NORTHEASTERN CONNECTICUT COUNCIL OF GOVERNMENTS
ENGINEERING PLAN, DRAINAGE REPORT AND WETLANDS REPORT REVIEW
PERTAINING TO
PROPOSED WILLOW HILL EVENTS WEDDING/EVENT VENUE
(ASSESSOR'S MAP 19, BLOCK 18 - LOTS 18A & 18B)
WOLF DEN ROAD
BROOKLYN, CT
(March 17, 2023)

The comments contained herein pertain to my further review of a revised set of plans entitled "Special Permit Application for Wedding/Event Venue for Willow Hill LLC, 459 Wolf Den Road, Brooklyn, Connecticut, Dated: November 30, 2022, Revised: March 8, 2023," prepared by J&D Civil Engineers, LLC and from observations made during a site visit by myself on March 14, 2023.

From: Daniel Blanchette <daniel@jdcivilengineers.com>
Sent: Tuesday, March 21, 2023 2:34 PM
To: Jana Roberson; Syl Pauley
Cc: Gregory Fisher
Subject: Revised Plans for 459 Wolf Den Road
Attachments: 22172 Wineland - Site Plans 2023-03-21.pdf

The following is an itemized response to Syl's second review letter:

JOB NO: 22172 **DATE: NOVEMBER 30, 2022**
SCALE: 1" = 20' **SHEET: 4 OF 6**

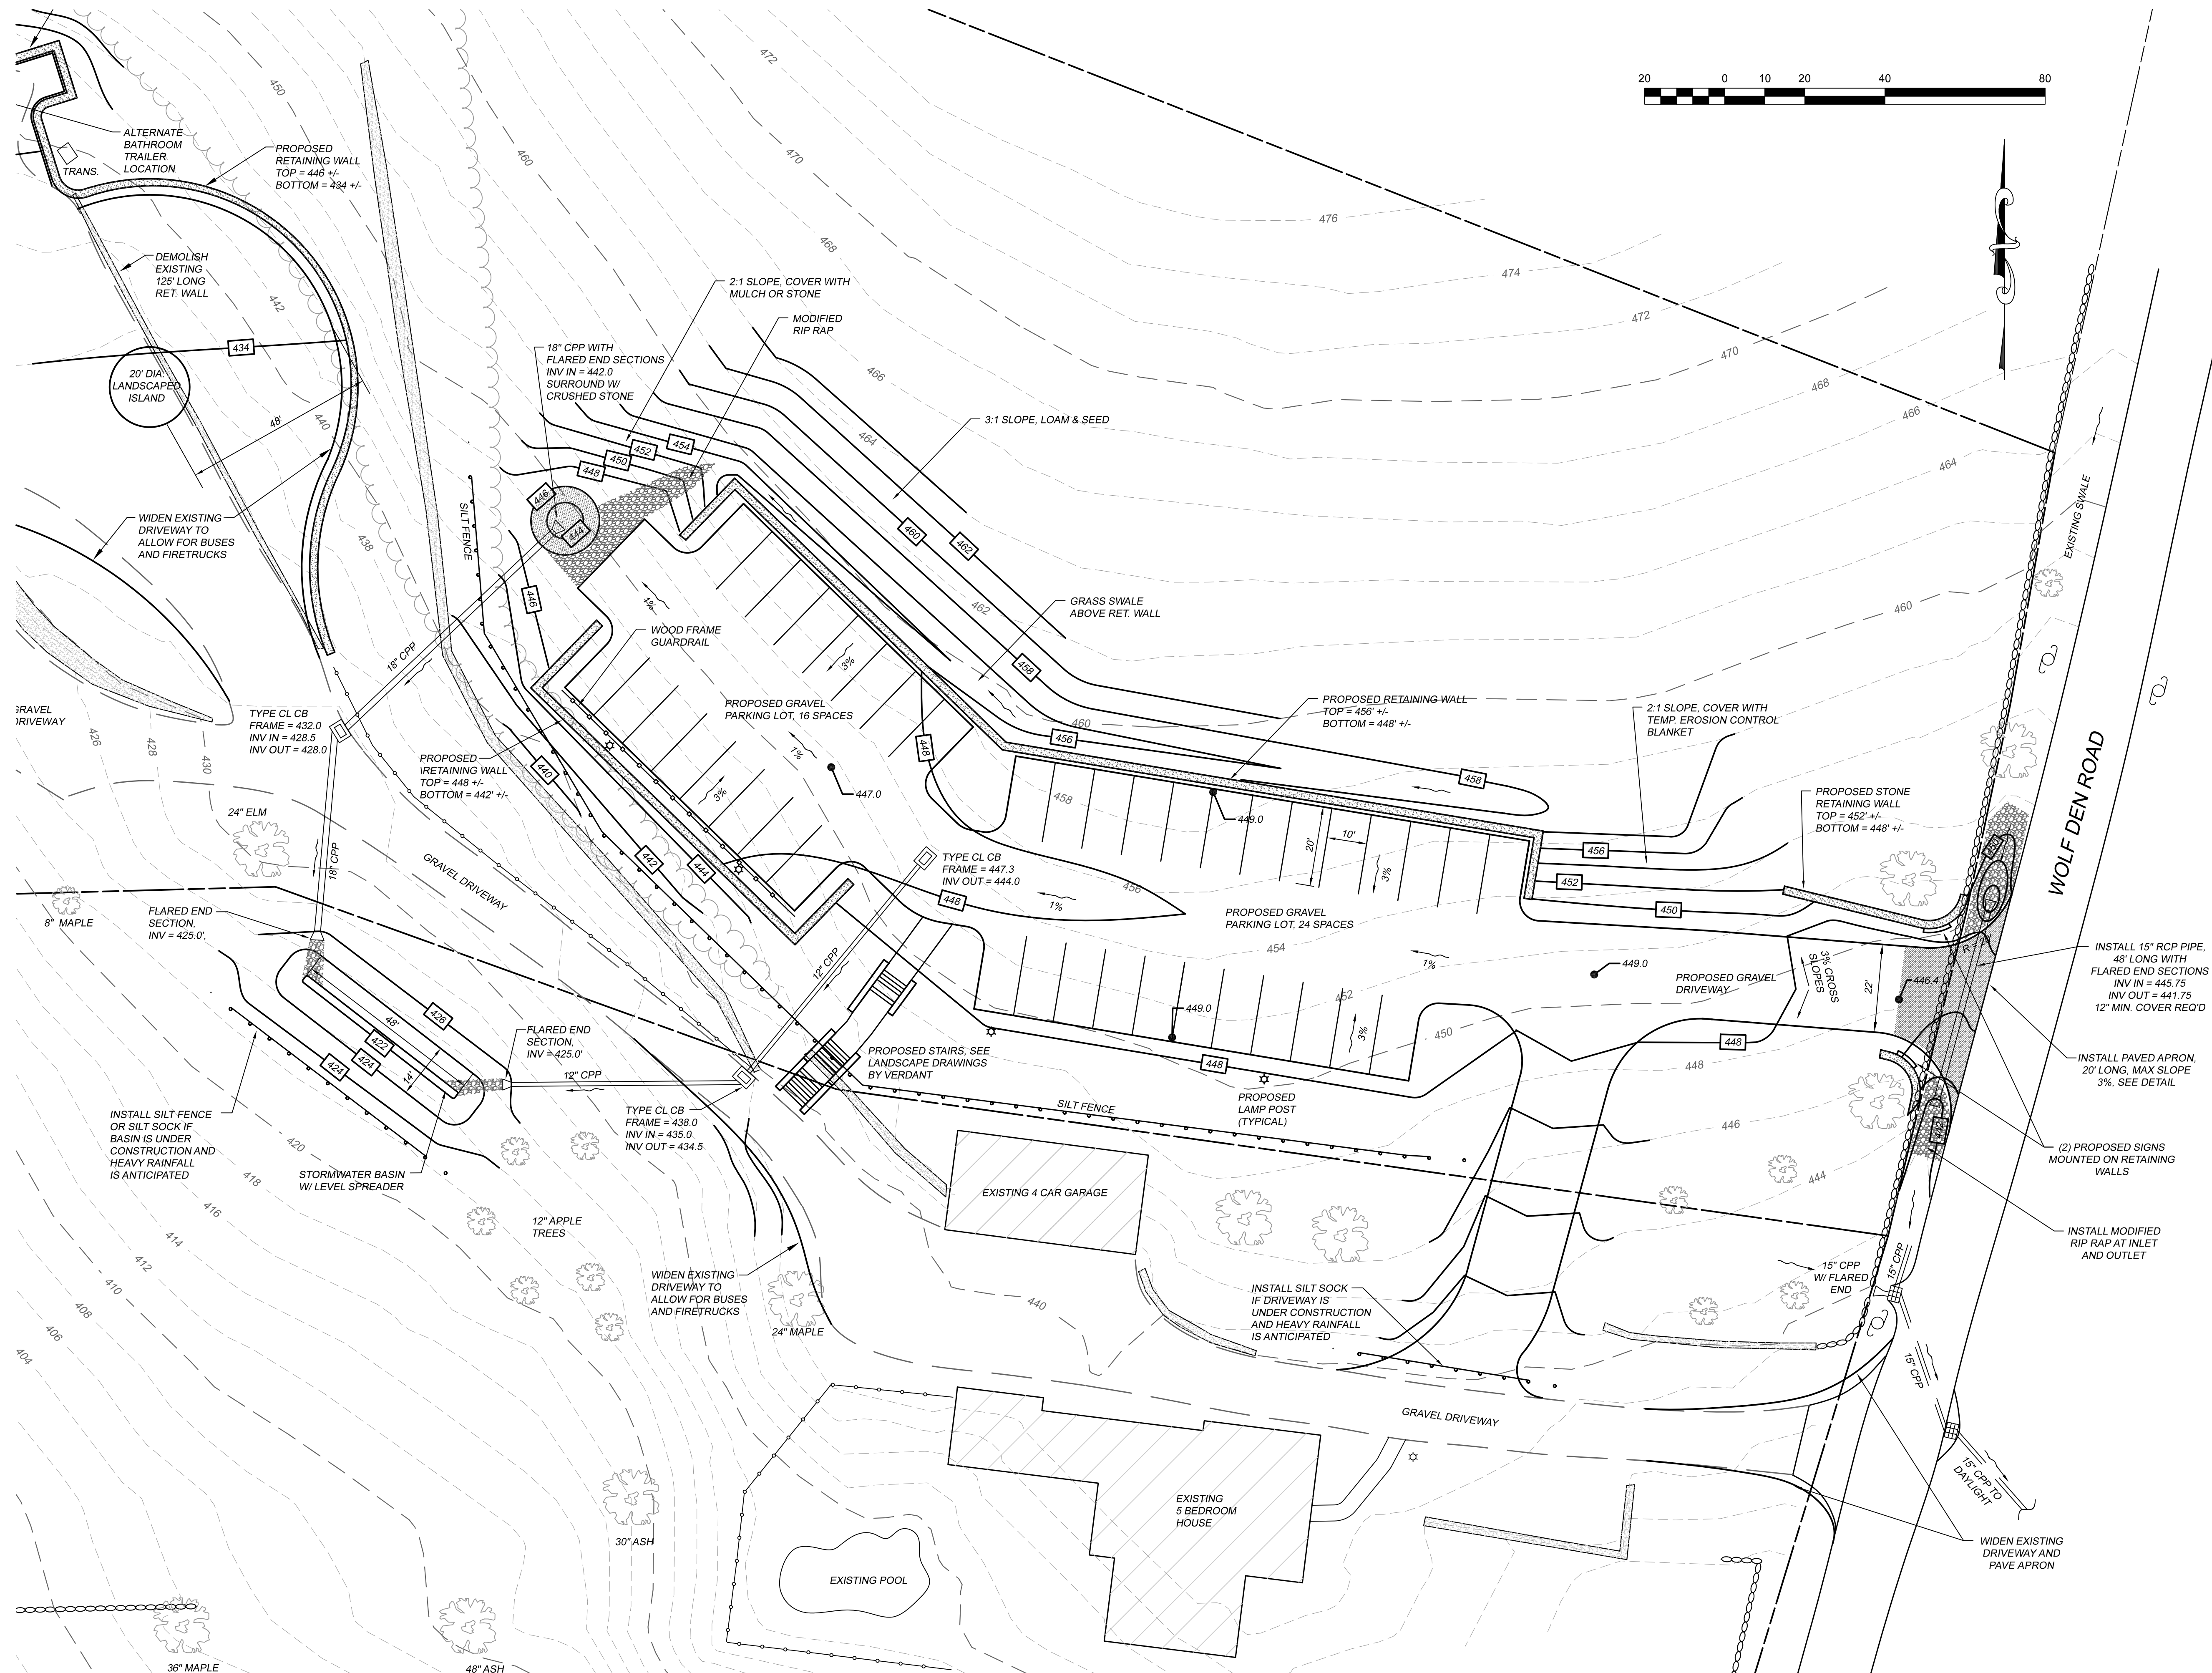
2. Existing drainage pipes/appurtenances must be shown at the catch basins within the Wolf Den Drive right-of-way.
3. The existing swale on the west side of Wolf Den Drive between the existing driveway and SNET Pole #447 needs to be defined more accurately with contour lines and a note. The existing contour lines drawn on the plan do not truly represent the presence of a swale.

4. The proposed driveway is shown with a depression at the edge of Wolf Den Drive and acts like a continuation of the upstream swale. This is unacceptable, as over time water will undermine the driveway and may cause a failure or an impact to the public street pavement, and, furthermore, causes a vehicle to possibly take an unexpected dip to enter Wolf Den Road and possibly cause an accident and/or passenger injury. The driveway must be constructed with a consistent slope and incorporate a 15" pipe underneath it with flared end sections on each end and riprap for swale protection. This will allow for free flowing water conveyed from upstream in the swale. The existing swale will require some modification for this. The modification of the "existing" driveway does not impact any swale as observed in the field.

2. Sheet 4 has been revised to include these existing drainage pipes
3. The contours has been edited to show the swale.
4. The driveway has been revised to include a 15" RCP culvert, with flared ends and riprap. I specified modified rip rap, I feel standard and intermediate would be too large.

DESIGNED: DBB	REVISIONS:
CHECKED: DRB	2023-02-05 TOWNS COMMENTS
	2023-03-21 SITE WALK
JOB NO: 22172	DATE: NOVEMBER 30, 2022
SCALE: 1" = 20'	SHEET: 5 OF 6

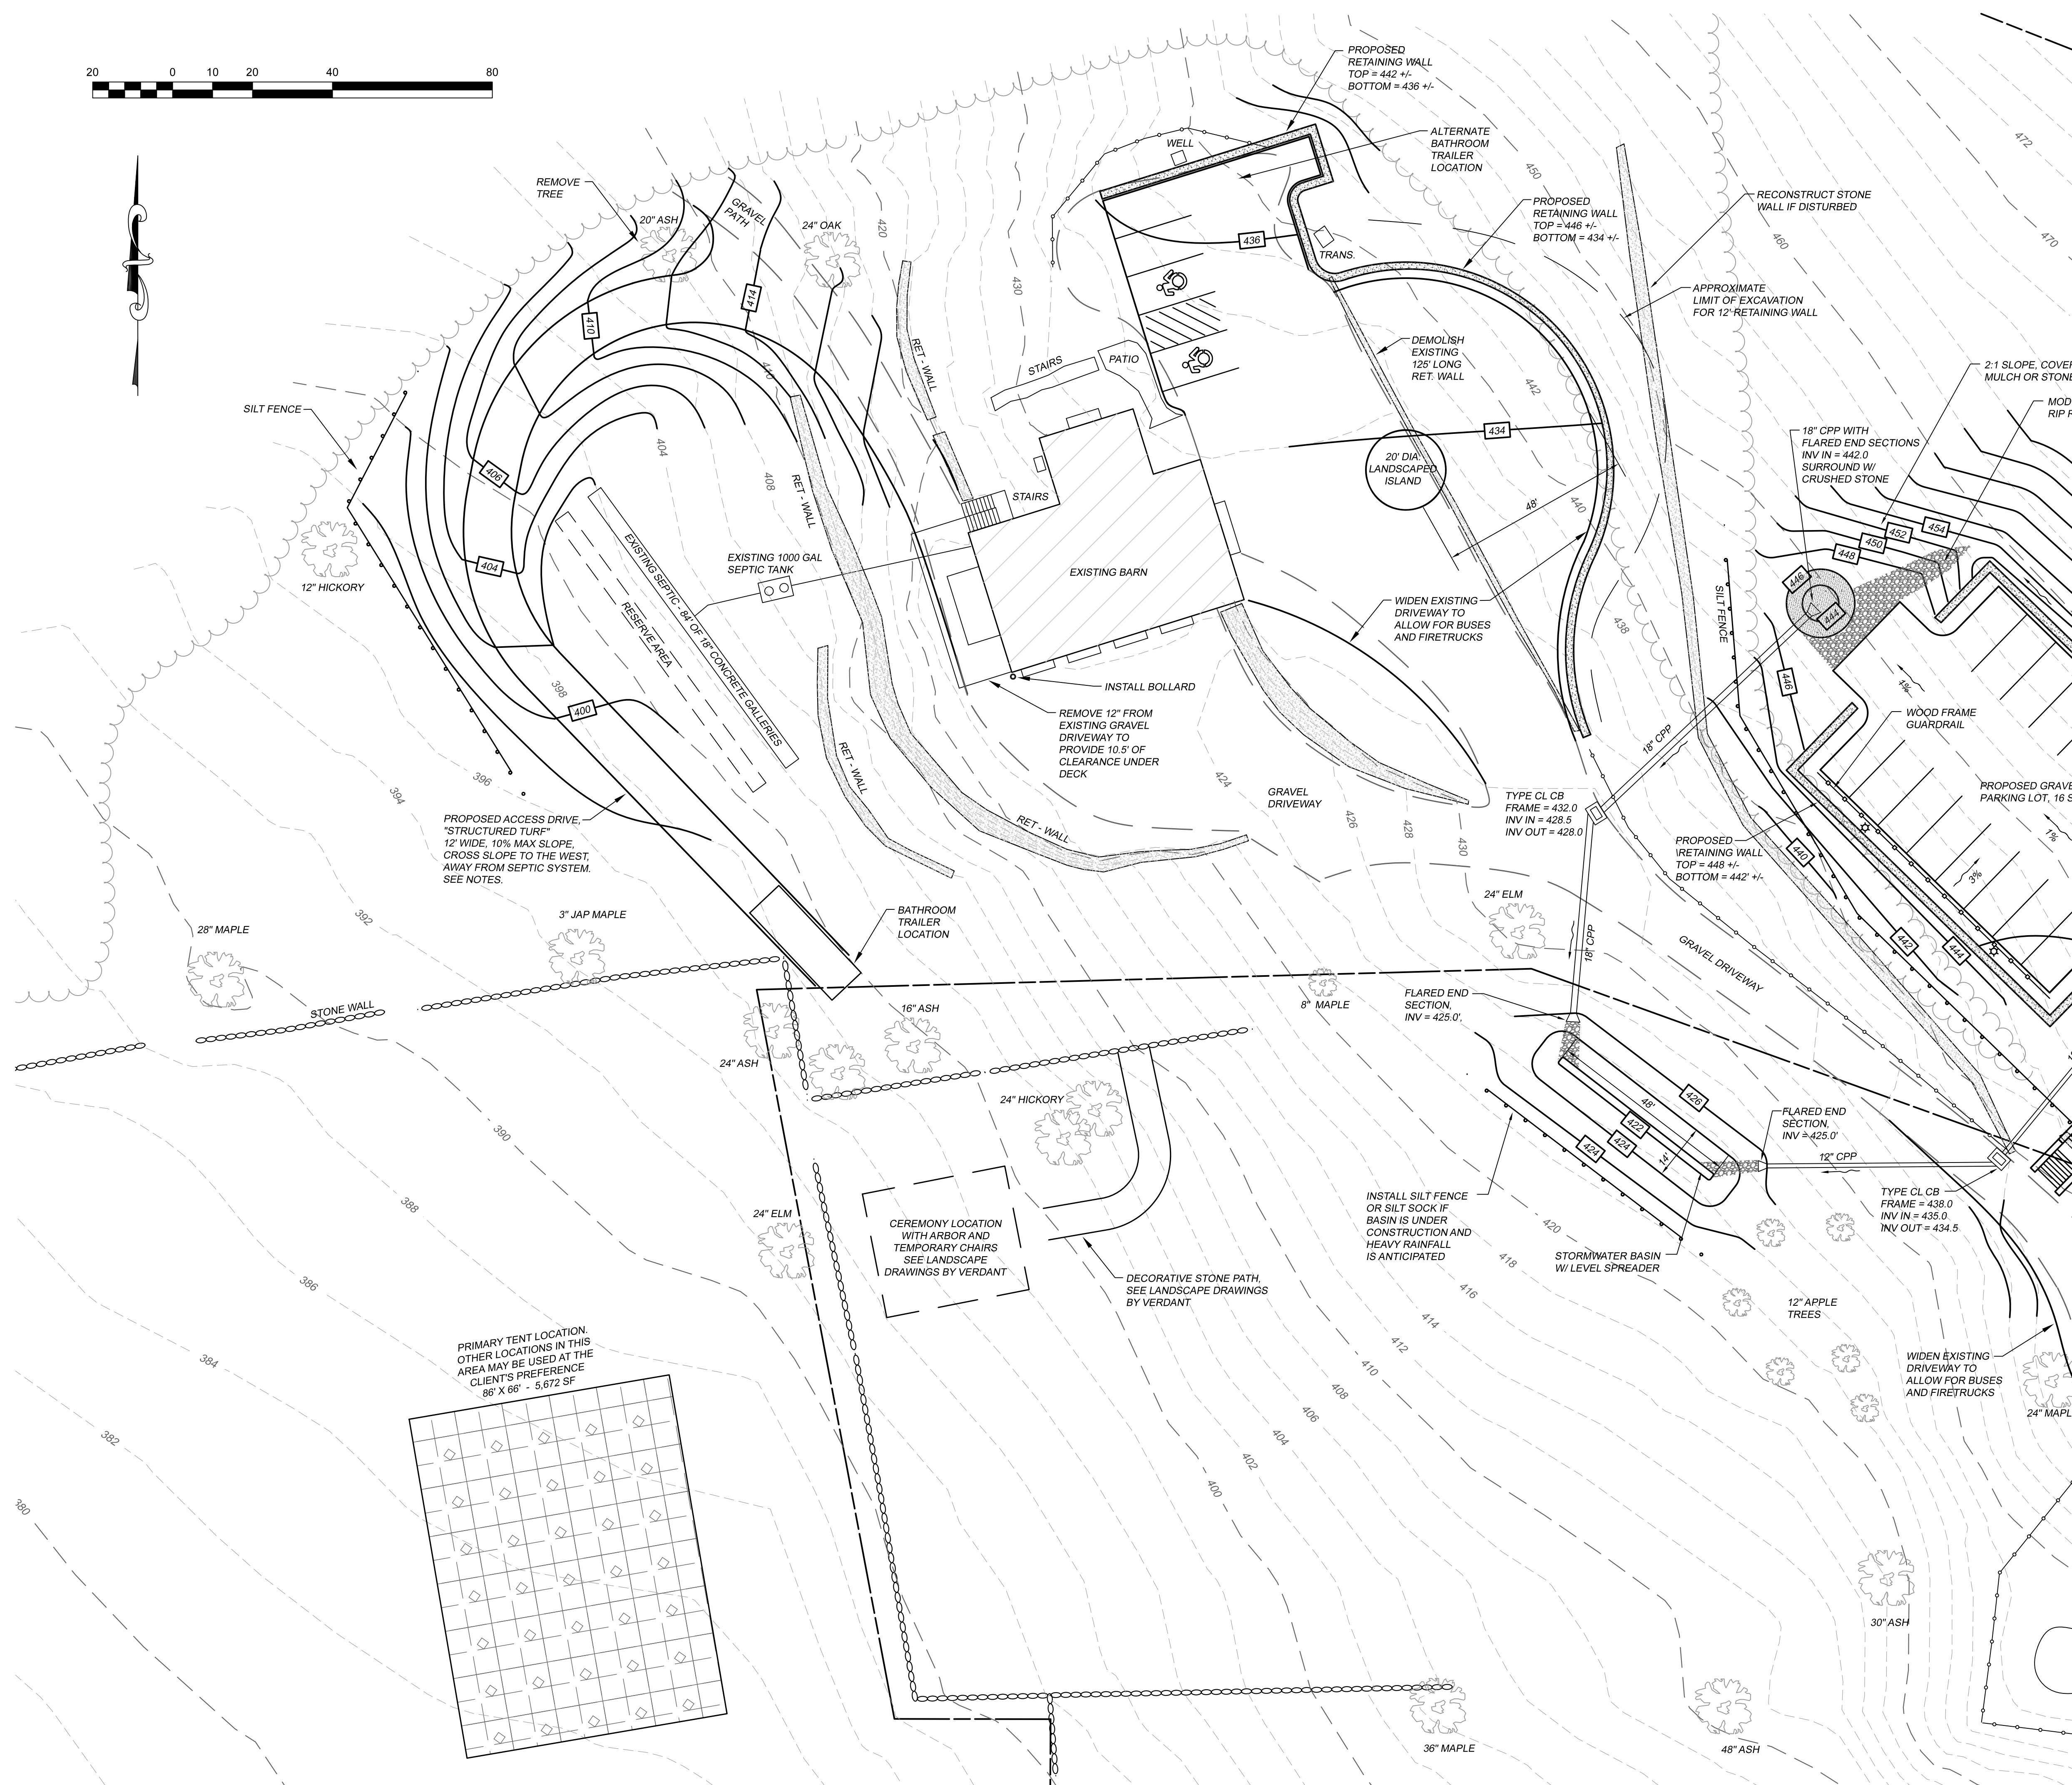
6. On Sheet 5 of 6, the driveway that goes under the lower deck attached to the existing barn needs to be shown as being under the deck (dashed lines). As drawn, the indication is that there is no driveway present.

8. The clearance under the lower deck attached to the existing barn has been measured to be less than 9.5' between the surface of the existing driveway and the most bottom surface of the deck fence post located in the middle of the deck (south side) over the driveway. The limited clearance will prevent most, if not all, vehicles larger than a pickup truck to safely pass underneath the deck—this may prevent passage of a bathroom trailer and large truck delivering a tent, both of which are mentioned on Sheet 6 of 6. If the deck height or driveway elevation is not modified to allow for the passage of larger vehicles, a sign needs to be posted on the deck and/or southwest corner of the barn stating that no vehicles taller than 8', with or without roof mounted accessories, are allowed to pass underneath the deck for risk of damage and/or personal injury. This needs to be stated on the plan, too. Also noted during my field inspection, is a passage door on the west side of the barn right at the southwest corner of the barn which is not visible to a vehicle approaching from the south. This clearly is a safety issue and should be addressed (signs?). Additionally, a bollard or bollards is/are needed to protect the southwest corner of the barn from vehicle impact.

5. The detail for drainage pipe installation has been revised.
6. The existing driveway under the deck is shown more clearly.
7. The applicants preference is for pea stone, and they are aware it will require more maintenance than typical processed gravel.

8. A note has been added to remove 12" of material from the existing driveway, to provide 10.5 feet of clearance under the deck. A note has also been added regarding the bollard at the building corner.
